Jervois Base Metal Project

SUPPLEMENT TO THE DRAFT ENVIRONMENTAL IMPACT STATEMENT

Jervois Base Metal Project
Supplement to the Draft
Environmental Impact Statement

Prepared for
KGL Resources Pty Ltd

Figure 2.1-1: Project Overview

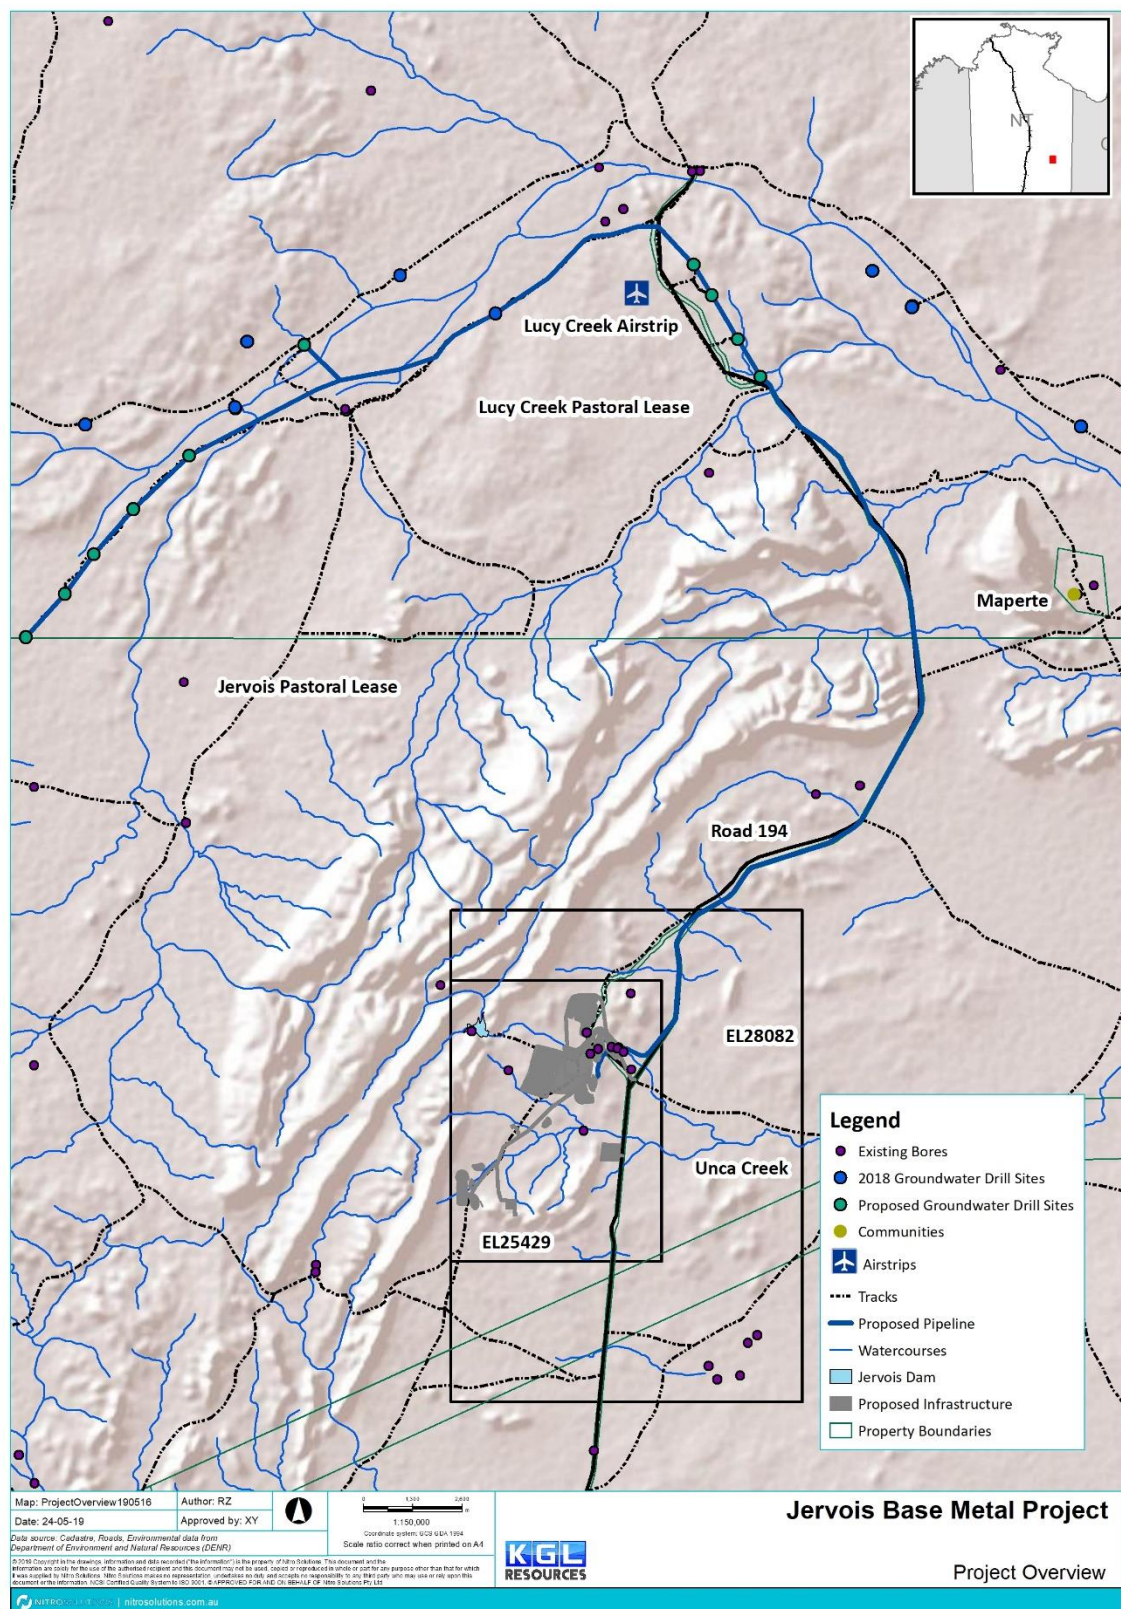
Clarify what the proposed action is, and therefore the scope of the Proposal to be assessed e.g. does the borefield and water pipeline form part of this proposed action, if so additional information is required (see below).

Include Lucy Creek Access Road 194 on maps e.g. Figure 2-1 (only provided in additional regional features map and in Traffic and Transport Impact Assessment).

- Open pit and underground mining;
- Processing plant for on-site processing of ore;
- Waste rock landforms;
- ROM pads;
- Fuel storage areas;
- Workshops;
- Concentrate load out facility;
- Power generation and supply facilities;
- Haul roads;
- Tailings storage facilities;
- Administrative, accommodation and maintenance facilities;
- A borefield; and
- Transport of ore off site.

Please refer to the Figures provided in Section 2.1 which show the location of all proposal components.

Figure 2.1-2: Proposed Project Layout

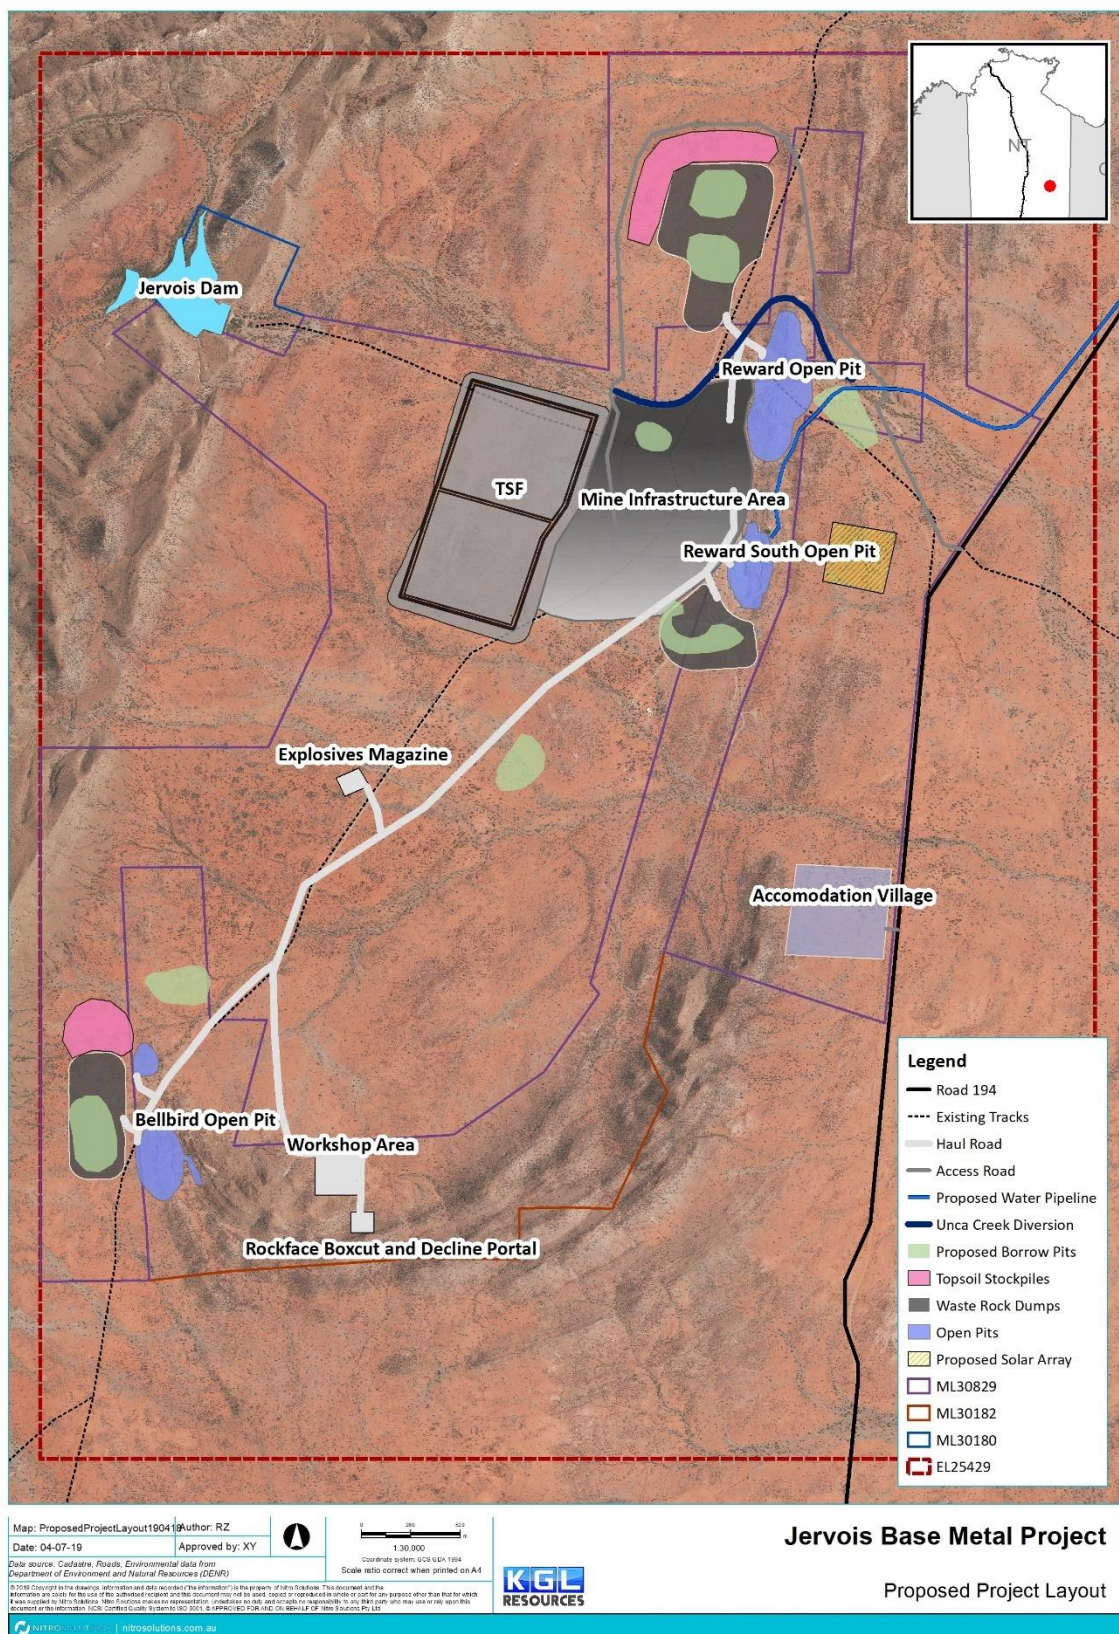
In response to a clarification request, the Proponent provided a new map of the proposed infrastructure and mining areas that differed to the one provided in the Draft EIS (Figure 2-1). In order to identify the scope of the assessment:

Identify if the omissions in Figure 2-1 constitute an alteration to the Proposal. If yes, identify if the environmental significance of the proposed action has changed (clause 14A Environmental Assessment Administrative Procedures).

As detailed in Section 2.1, further Project planning has identified potential borrow pits located within the MLs (Figure 2.1-2). These pits have been located within historic and proposed disturbance areas wherever possible to reduce the overall Project disturbance. The disturbance associated with these areas has been considered within the Supplement Report impact assessment updates which include guidance for rehabilitation and management of land disturbances.

The omissions in Figure 2-1 do not constitute an alteration to the proposal. These are errors in the original mapping as explained in the responses to comments 1 and 6 above, and in the proposed mining sequence in the draft EIS and Section 2.2.2 of this Supplement Report.

Figure 4.5-7: Random Walk Particle Tracking and Drawdown Contours from the End of LOM Year 10

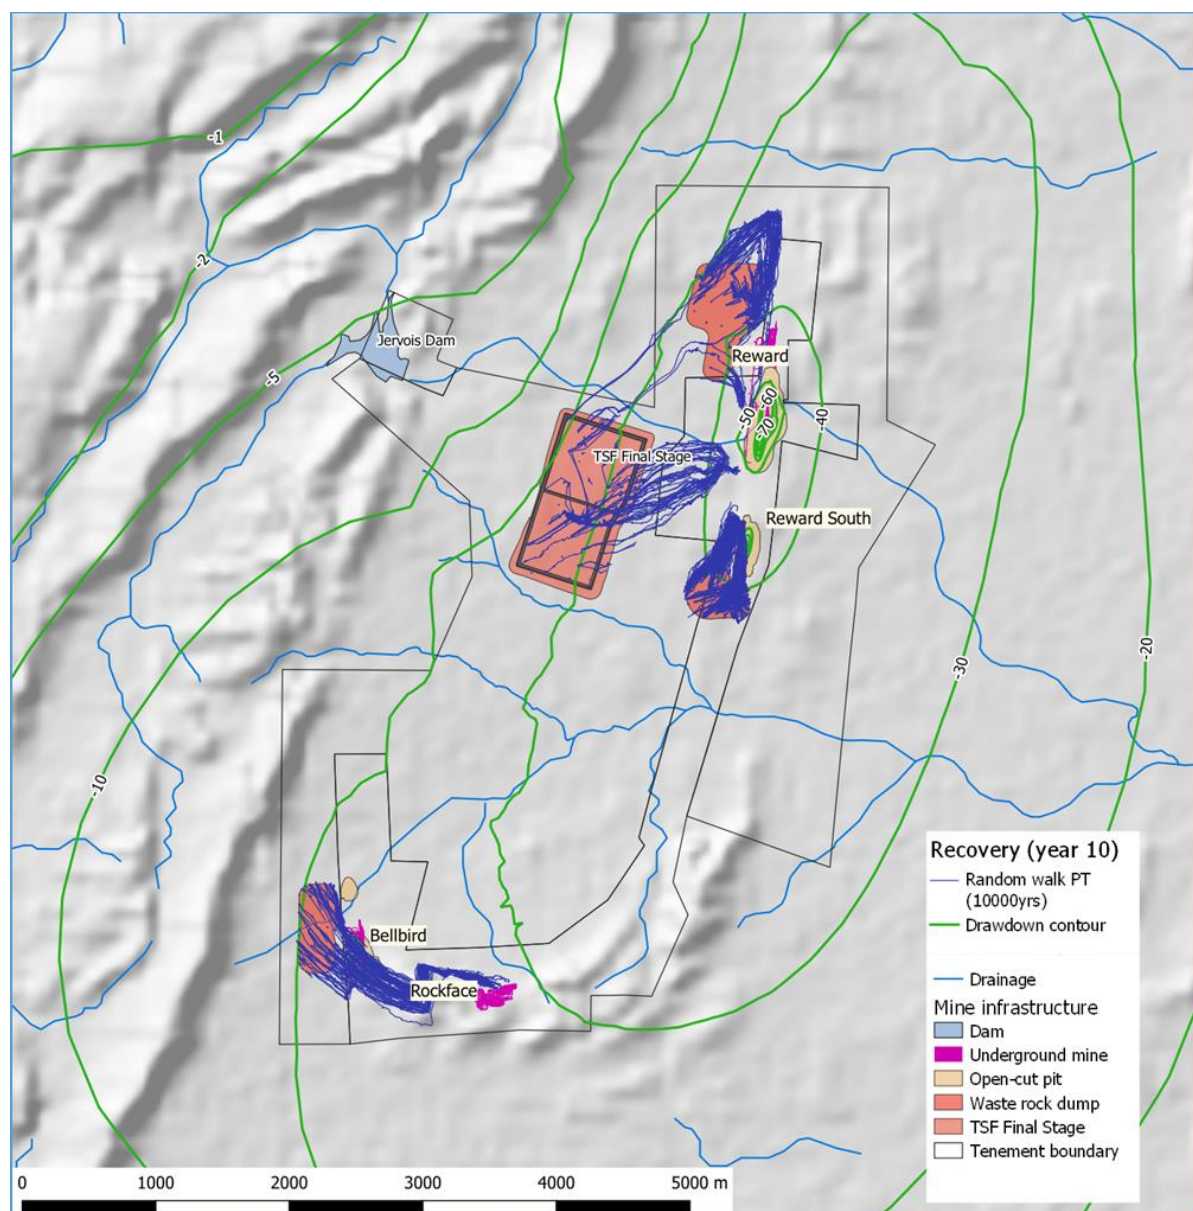
- *The south cell of the evaporation pond should be moved so that modelled particle tracking intercepts the pit lakes 'at the end of life of mine year 10' (C-6.7.3.2 and related figure 7-25).*

The EIS modelling for particle tracking shows that there is a risk for particles seeded beneath the south cell of the Tailing Storage Facility to not be captured by the cone of groundwater level depression developed at the end of mining. If the groundwater gradient is not towards the pit-lake (C-6.7.3.2 and figure 7-25 Random walk particle and drawdown contours at the end of LOM year (3650d)) it would travel to the southeast. The recommendation is to move the south cell so that possible seepage does get captured.

Figure 4.5-9: Proposed Water Management System for Bellbird and Rockface Operation

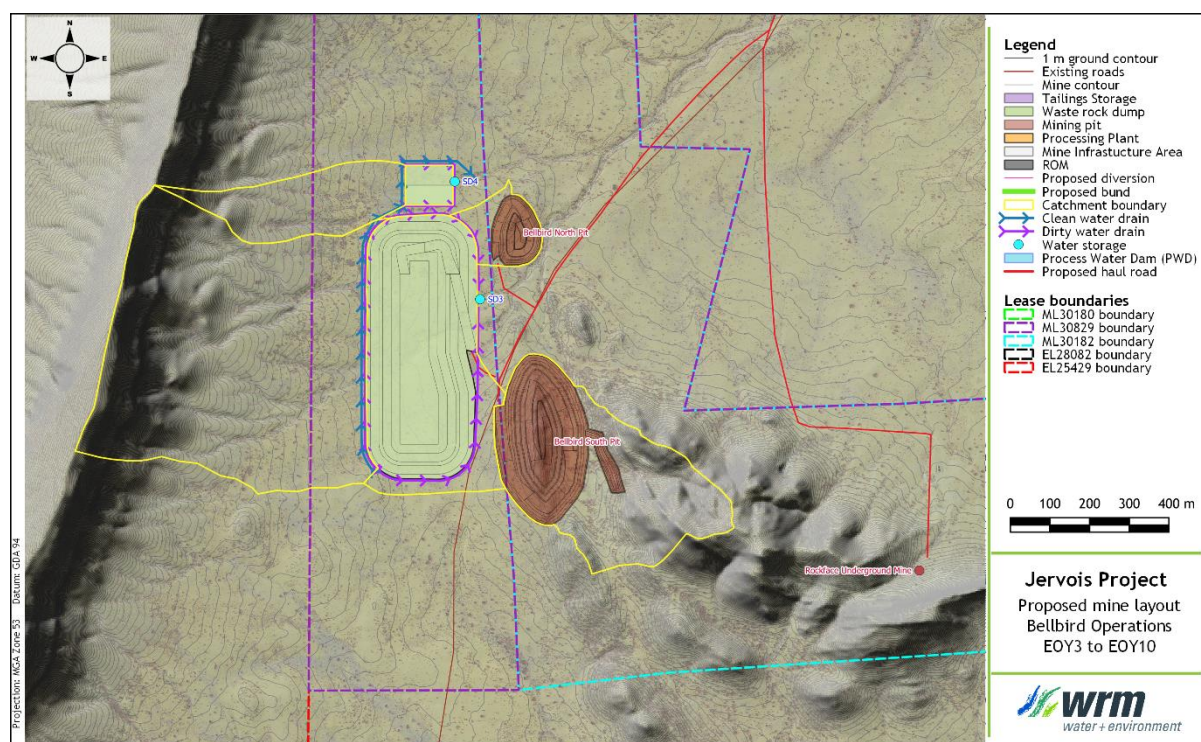
Provide Figure 3.1-16 with readable labels.

High resolution images have been included with the report where necessary. Please refer to Figure 4.5-9 provided in Section 4.5.
